Technical Service Bulletin

26-TSB-483-EN

Models and Markets: All STATIM 2000 and 5000 units with G4+ LCD controller boards worldwide

Description: Software update available SL12R103 (for G4+ LCD controller boards only)

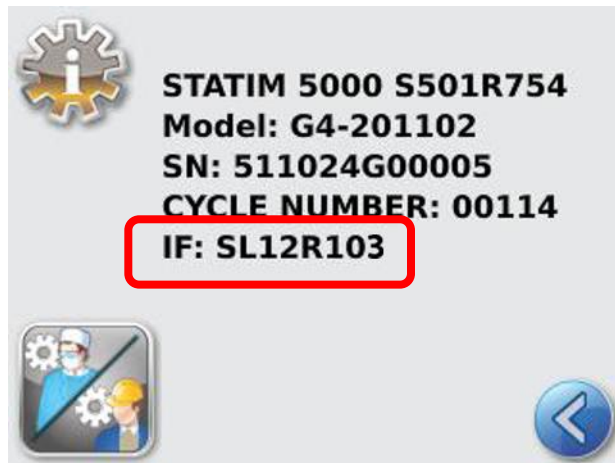
2. What issues will this fix?

This software update will correct the bubble level drifting and bubble level lost calibration issues.
